Errata Sheet

August 8, 2003 / Release 1.0

Device:	**SAB-C161PI-LM, -L25M** **SAF-C161PI-LM, -L25M** **SAB-C161PI-LM3V** **SAF-C161PI-LM3V** **SAB-C161PI-LF, -L25F** **SAF-C161PI-LF, -L25F** **SAB-C161PI-LF3V** **SAF-C161PI-LF3V**
Stepping Code / Marking:	**ES-CA, CA**
Package:	**P-MQFP-100-2, P-TQFP-100-1**

Timing of flag SSCTIR (SSC Transmit Interrupt Request)

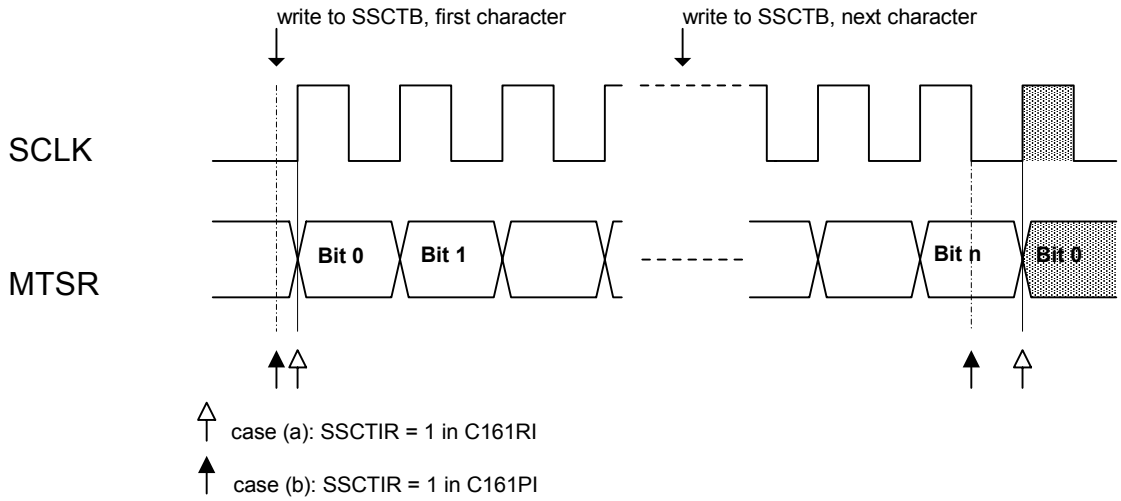
(a) in the **C161RI**, flag SSCTIR is set to '1' synchronous to the shift clock SCLK 1/2 bit time before the first latching edge (= first shifting clock edge when SSCPH = 0). When SSCTB is written while the shift register is empty, the maximum delay between the time SSCTB has been written and flag SSCTIR=1 is up to 1/2 bit time.

(b) in the **C161PI**, when SSCTB has been written while the transmit shift register was empty (and the SSC is enabled), flag SSCTIR is set to '1' directly after completion of the write operation, independent of the selected baud rate. When the transmit shift register is not empty when SSCTB was written, SSCTIR is set to '1' after the last latching edge of SCLK (= 1/2 bit time before the first shifting edge of the next character). See also e.g. C167CR User's Manual V3.1, p. 12-5.

The following diagram shows these relations in an example for a data transfer in master mode with SSCPO = 0 and SSCPH = 0. It is assumed that the transmit shift register is empty at the time the first character is written to SSCTB:

In order to achieve a defined and systematic behavior with all device steps of the C161PI/RI, the SSC receive interrupt, which is generated at the end of a character transmission, may be used instead of the SSC transmit interrupt.
